Agenda
Planning Commission
Wednesday, 20 June 2018 – 7:00 P.M.
City Hall-Council Chambers, 1 S Huron St
Ypsilanti, MI 48197

Agenda
Planning Commission
Wednesday, 20 June 2018 – 7:00 P.M.
City Hall-Council Chambers, 1 S Huron
Ypsilanti, MI 48197

Regarding: 203 N. Summit St
Site Plan Review No. 1
OHM Job No. 0094-18-1040

PRELIMINARY 3 COTTAGE UNITS
FOR 203 N. SUMMIT STREET
YPSILANTI, MICHIGAN

DEMOLITION PLAN & PROPOSED CONDITIONS

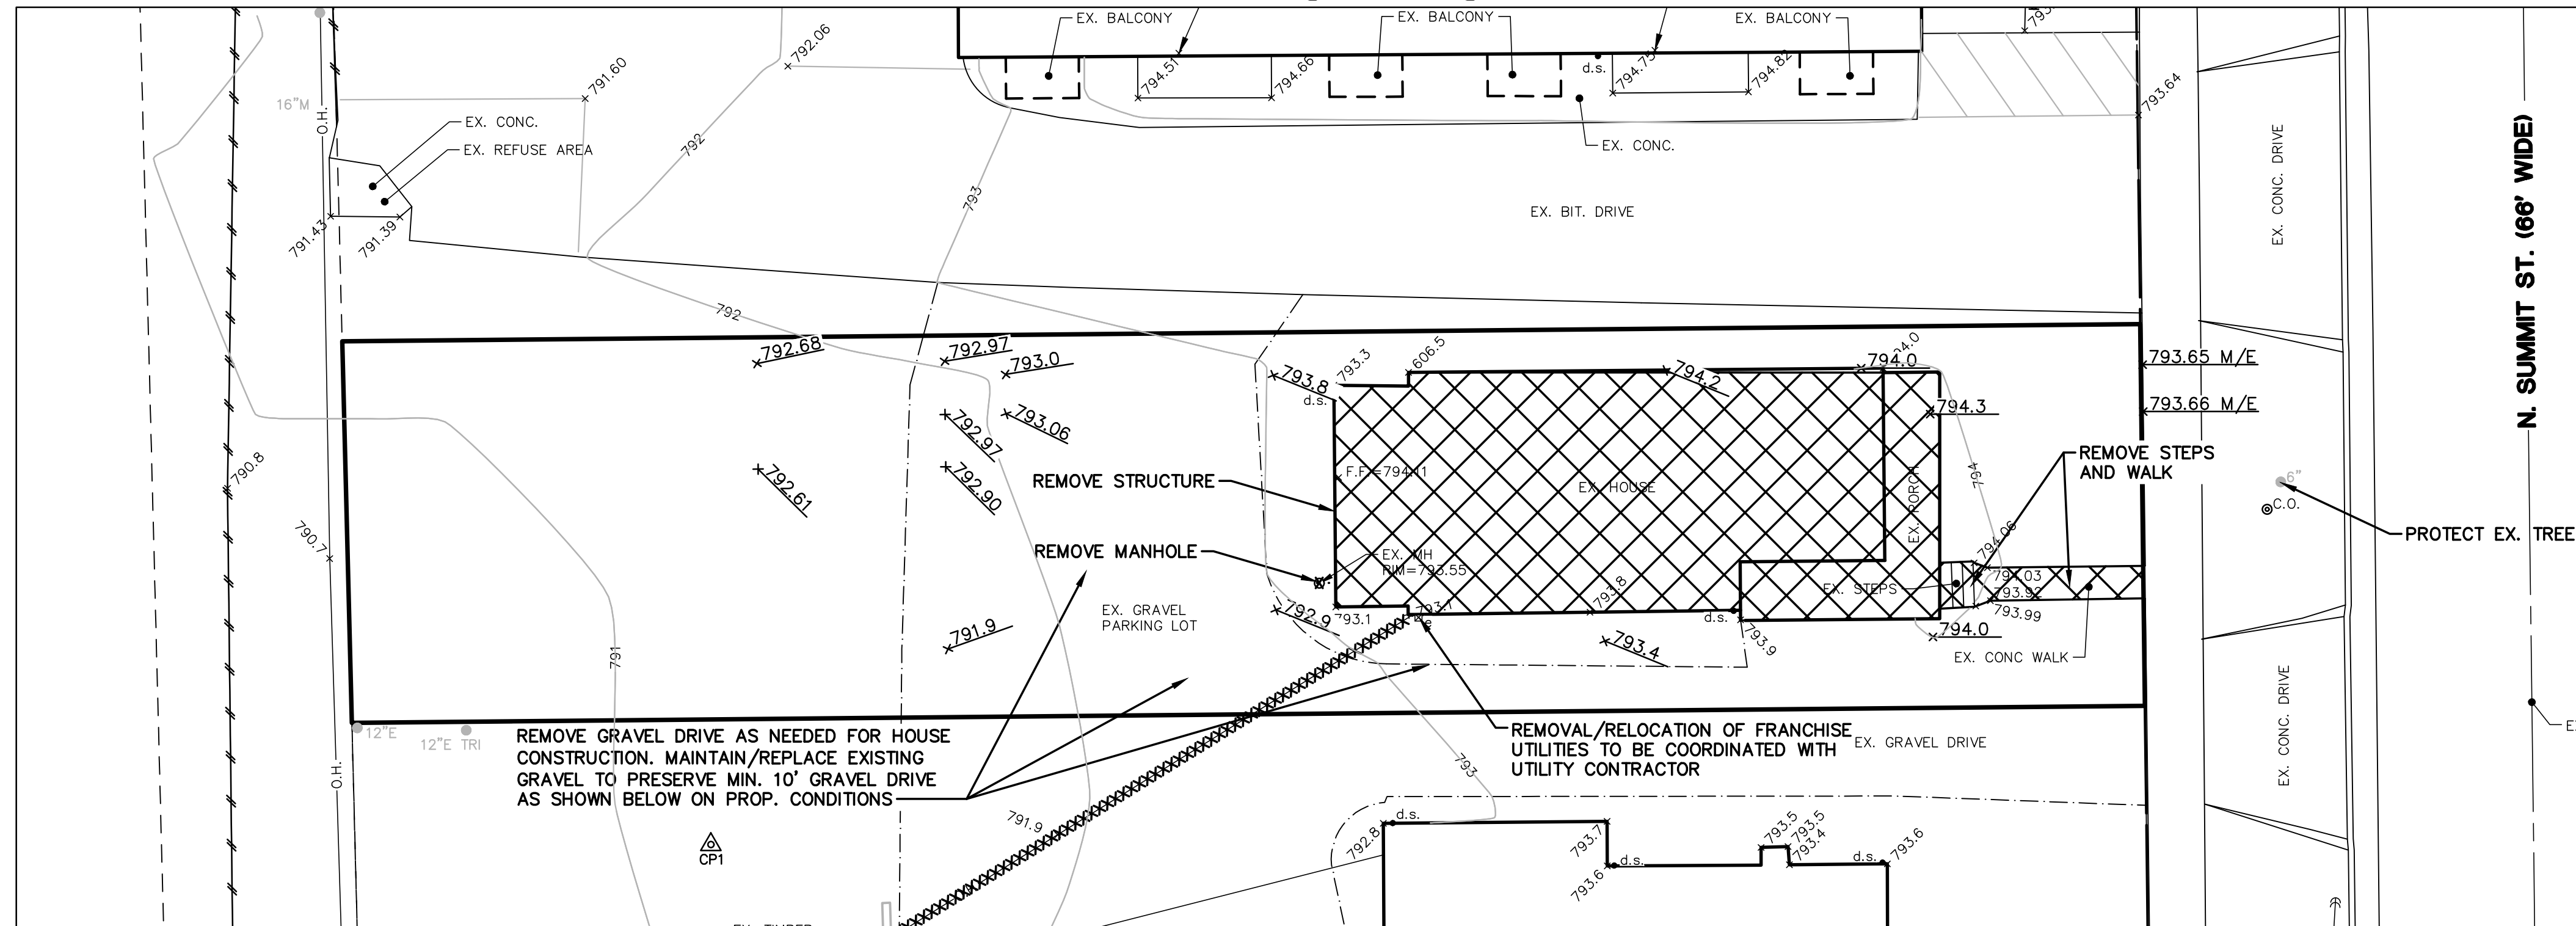
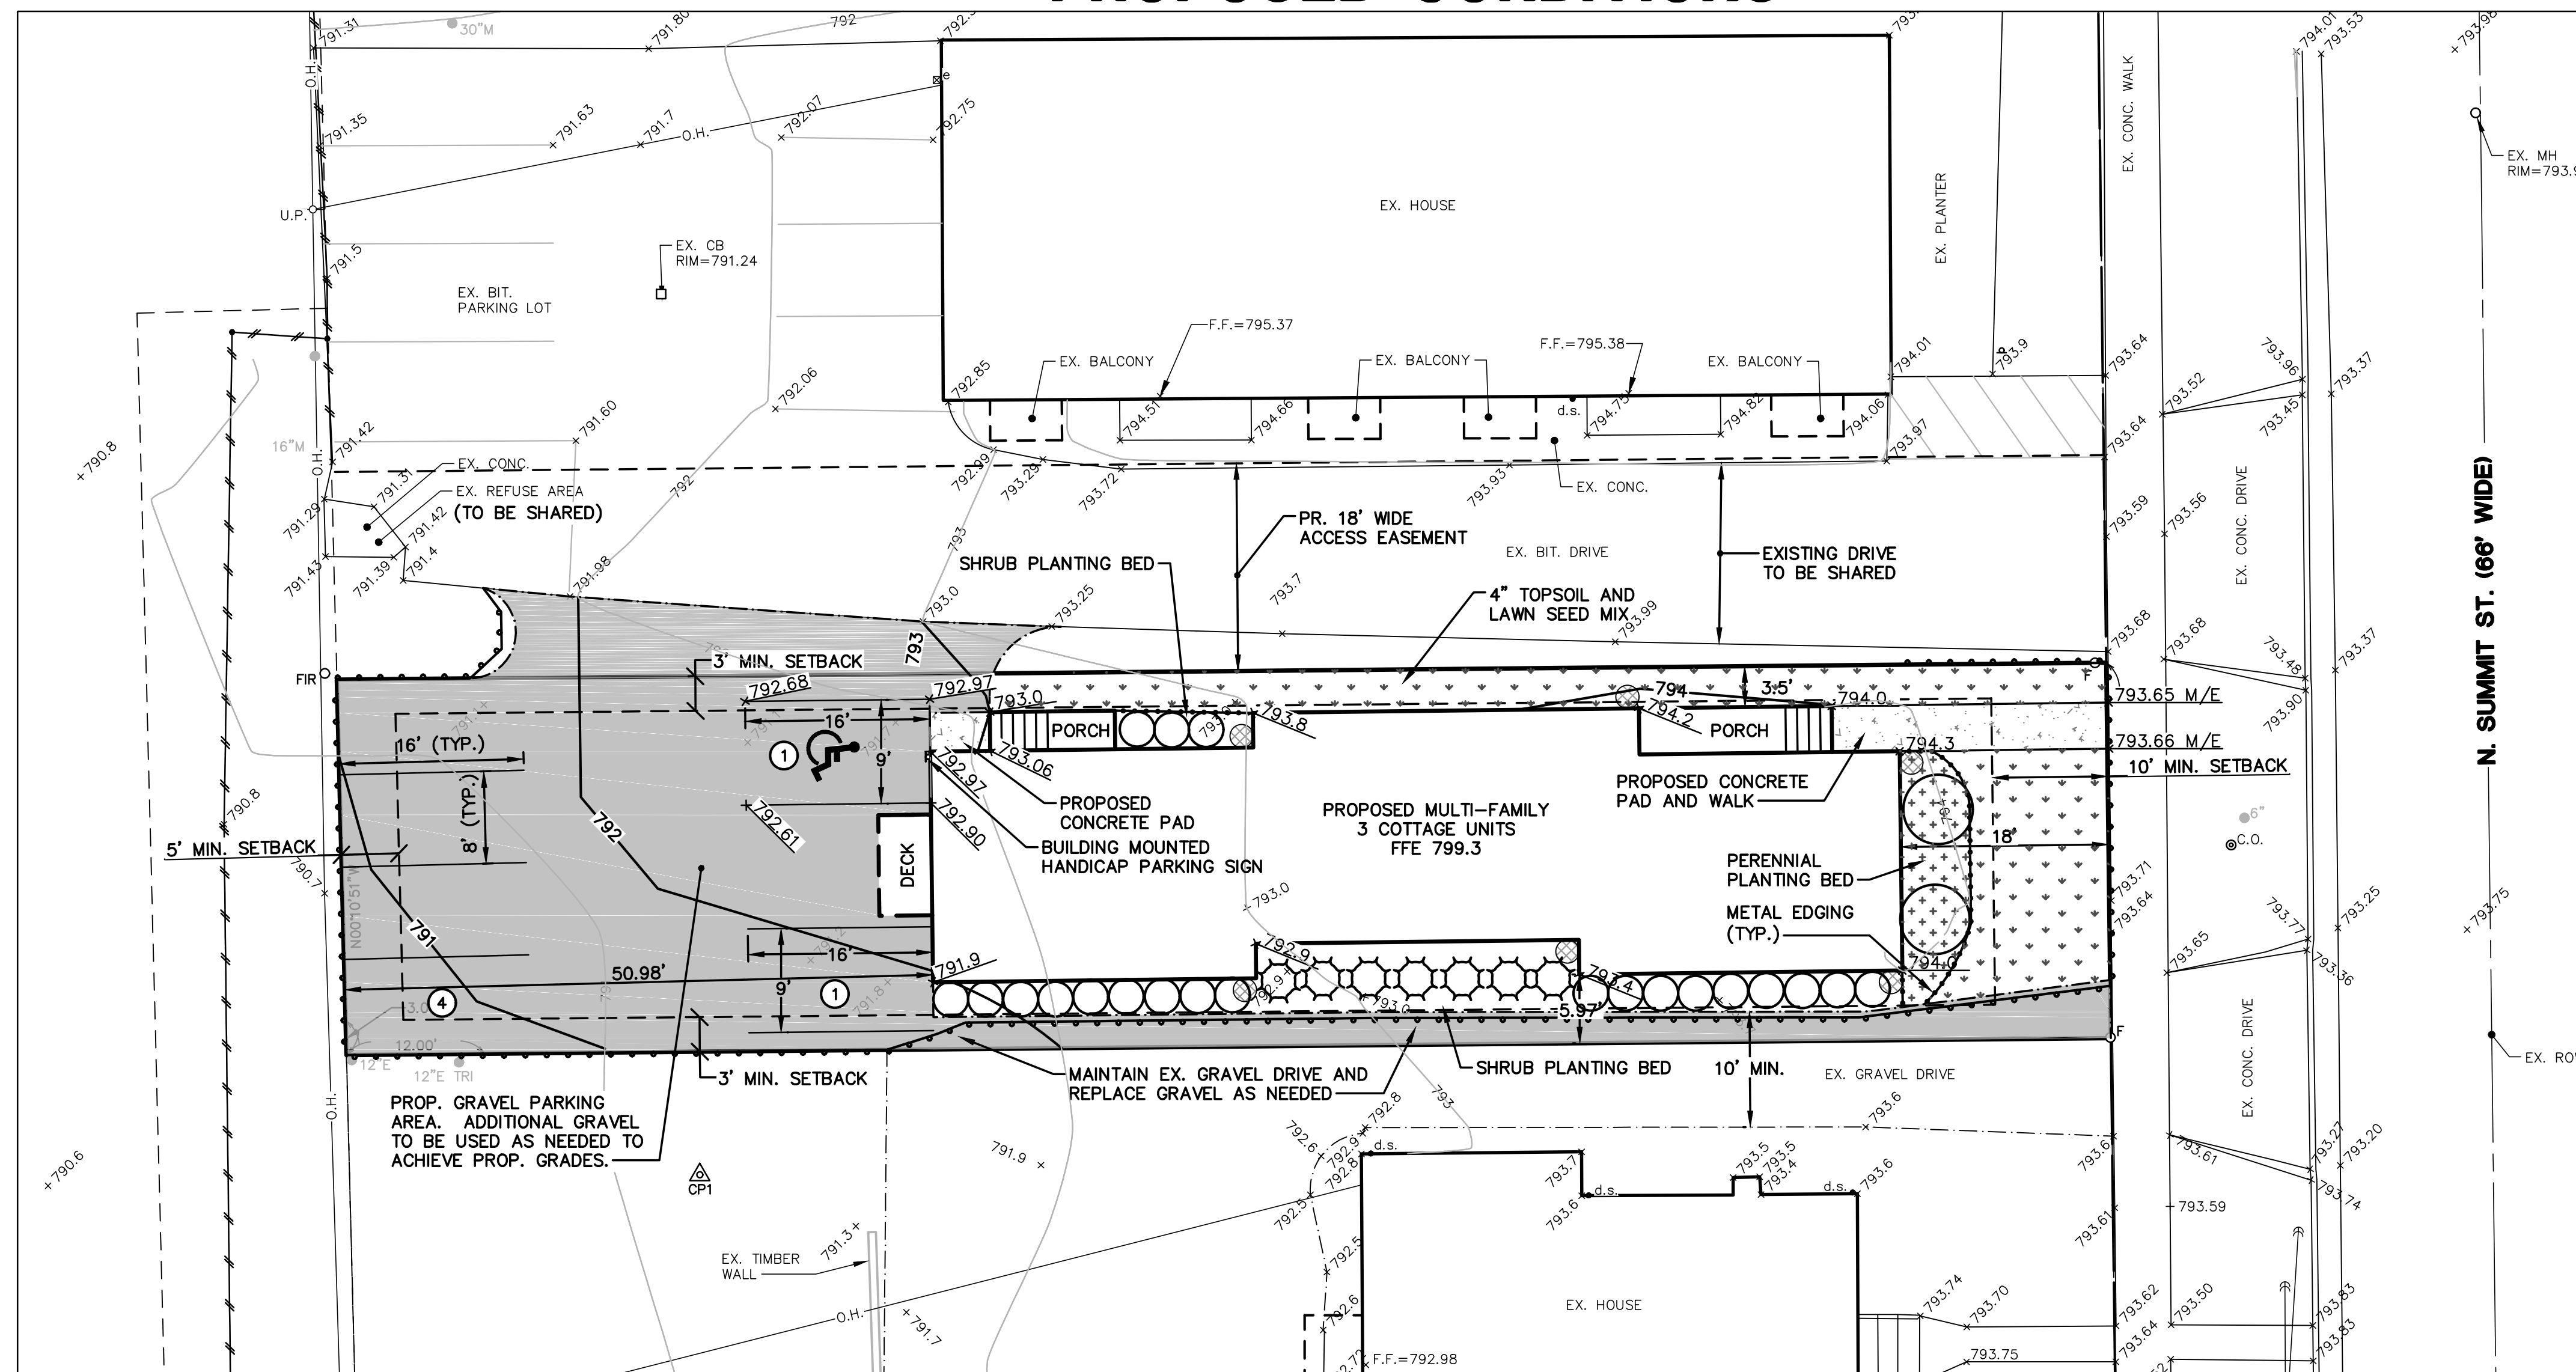
1. The applicant shall review the City of Ypsilanti's parking standards and revise the dimensions of both the parking spaces and maneuvering lanes to comply with City standards in accordance to Sec. 122-685 of the municipal code.

2. The applicant shall add benchmarks to the topographic plan.
3. The plans shall include the location of all existing underground utility lines (i.e. water, sanitary, storm sewer, franchise, etc.).

4. It appears the applicant is proposing a gravel parking lot. Per City ordinance, surface alternatives to pavement may be considered (see Section 122-683). The applicant shall pave an apron into the proposed gravel parking area (minimum 5-feet). In addition, the proposed handicapped parking space must be paved to maintain compliance with ADA regulations. The plans shall be reviewed and revised accordingly.

5. The applicant shall review the proposed handicapped parking space to ensure ADA compliance. Additional spot elevations for the parking space as well as the sidewalk at the entrances shall be provided for verification purposes. In addition, plans shall include ADA compliant sidewalk ramp details on the plans (i.e. current MDOT R-28 series, etc.).

6. It appears there is an existing dumpster servicing the adjacent property to the north. Plans shall include the existing dumpster location and provide clarification if it is to be relocated. In addition, clarification is also needed to determine if this existing dumpster will serve this site in addition to the existing neighbor. An agreement with the adjacent property owner may need to be established if the dumpster is proposed to be shared.

8. The applicant shall include any removals of existing landscaping or trees on the plans.
9. It is recommended the applicant label the addresses of the adjacent properties on the plans.

FIRST FLOOR PLAN

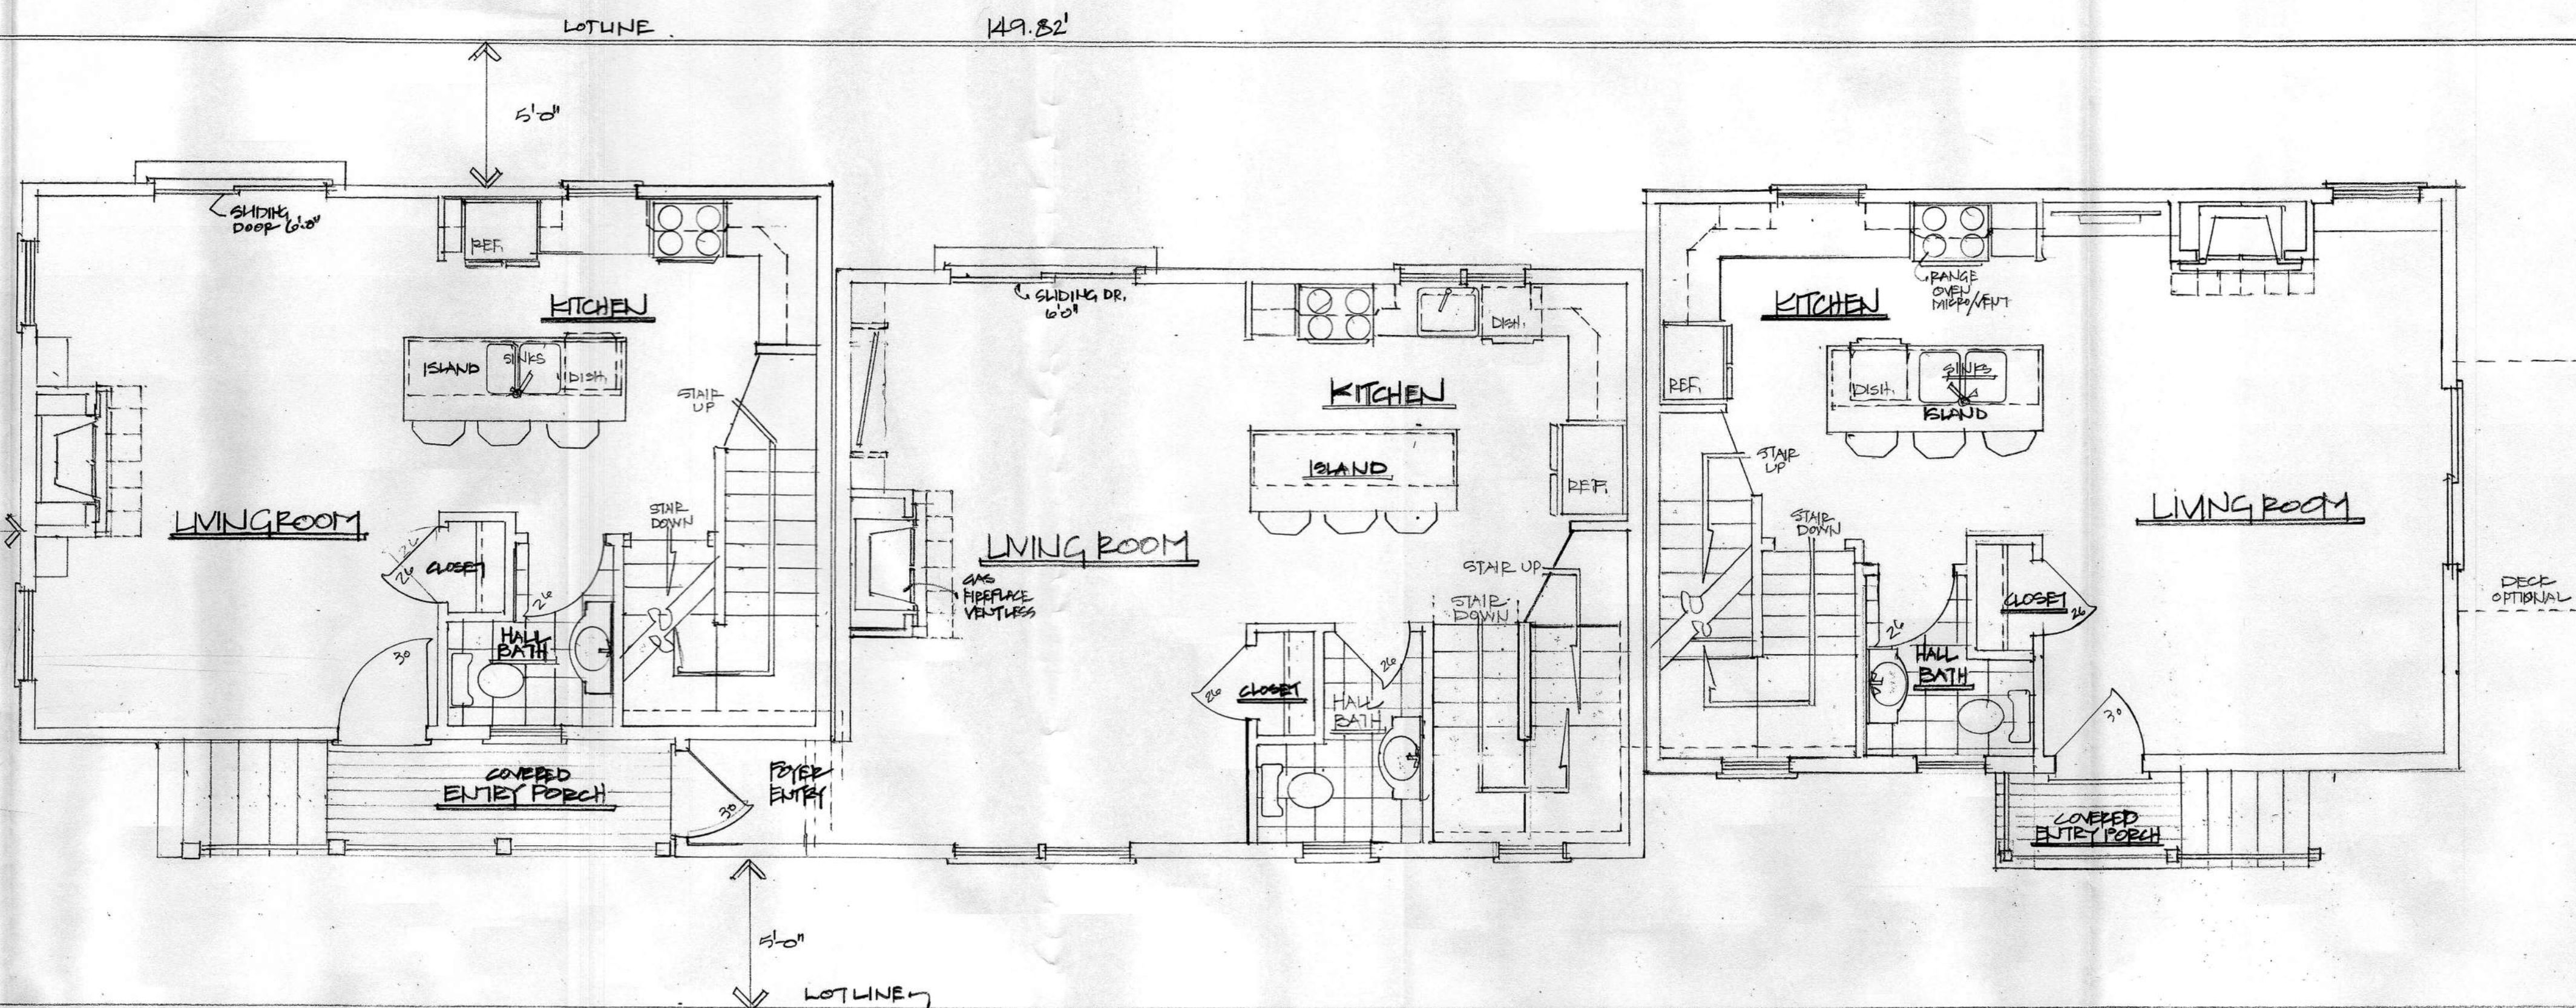
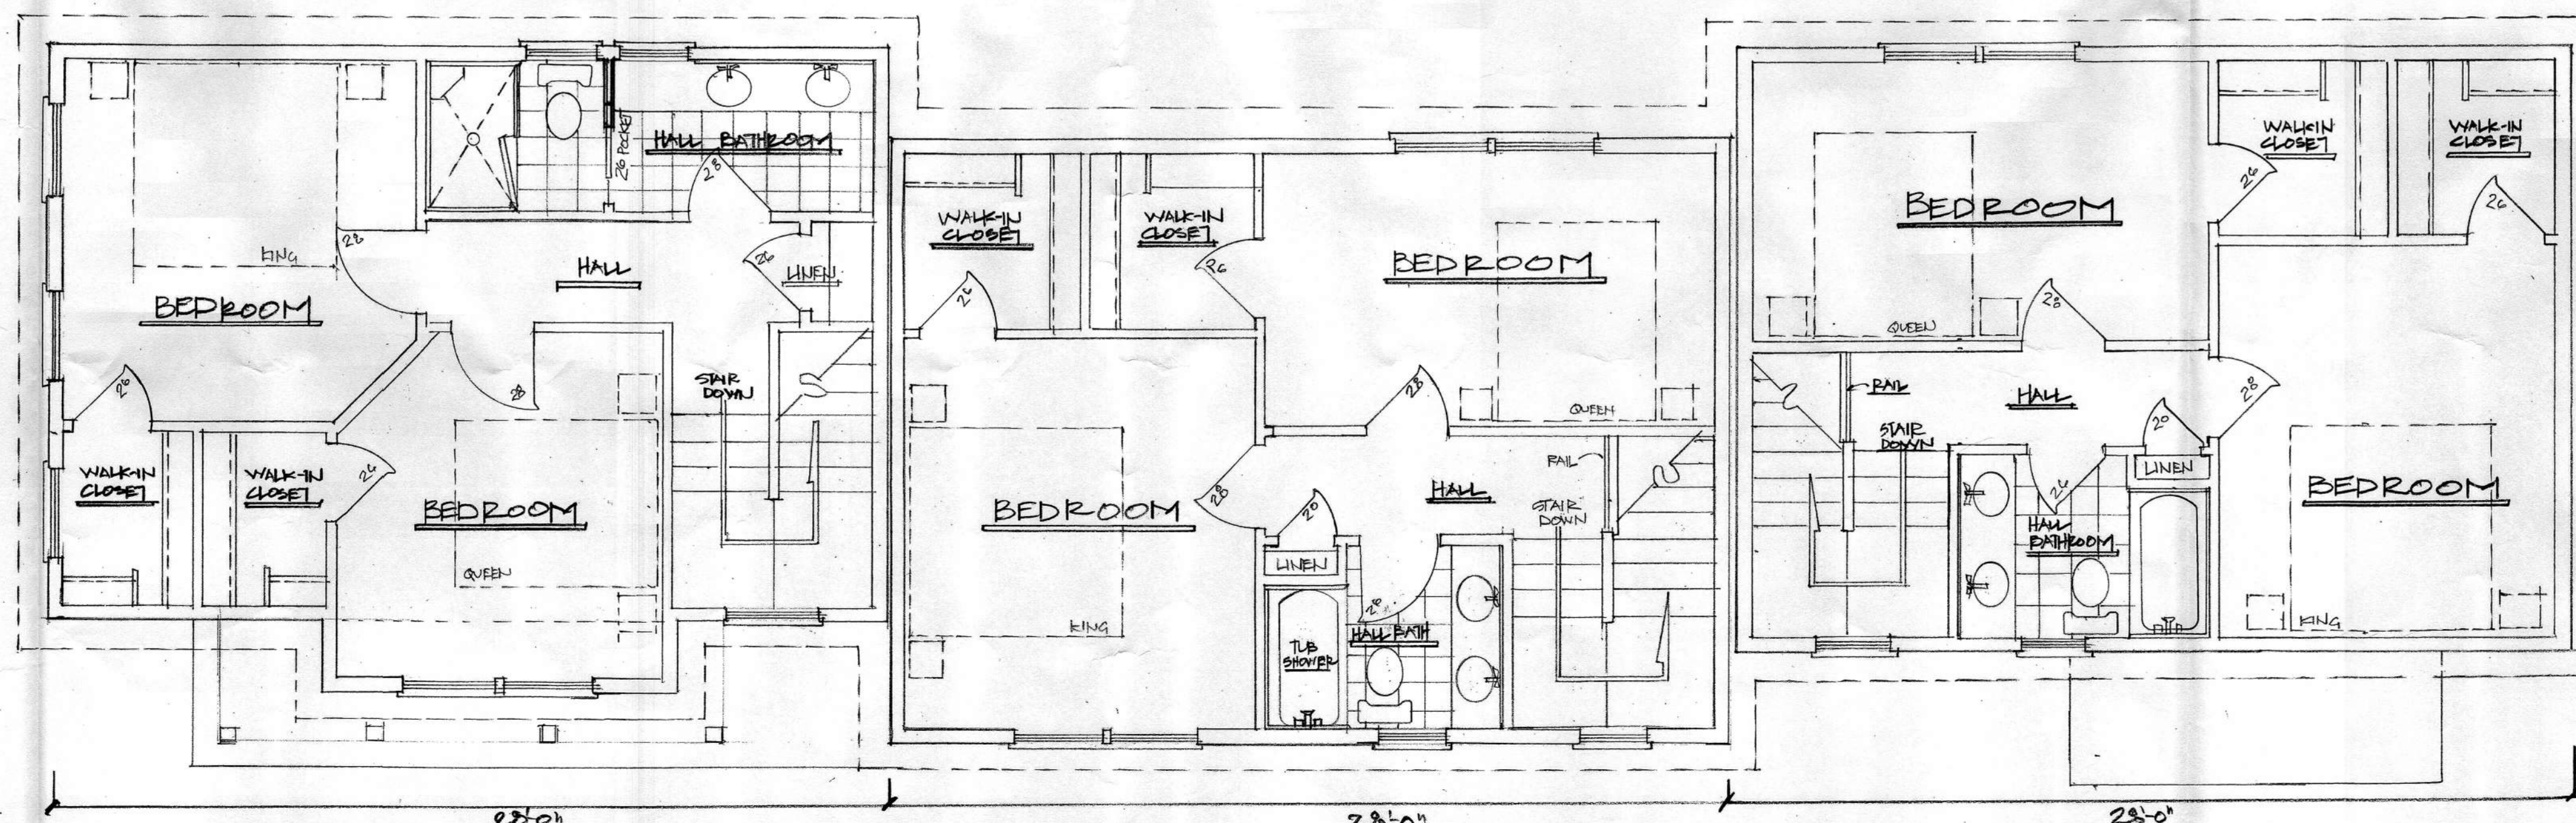
1. Applicant to provide a front entrance to the structure or to apply for a variance to permit the door locations to remain as proposed on the side of the house.

2. Applicant to provide an easement for the shared access drive to the north of site.
3. Applicant to provide parking spaces in the required dimensions of 9' x 18', one space may be a small car space at 8' x 16' with the required signage.

4. Applicant to pave the accessible parking space, provide an access aisle and correct the length of the space.
5. Applicant can utilize a gravel lot once the engineering requirements for the paved accessible space and paved apron to the gravel lot are provided.

8. Applicant to provide one tree internal to the site.
9. Applicant to provide curbing for all aisle-ends & corners.
10. Applicant to provide curbing or wheel stops to protect shrubs at SW corner.
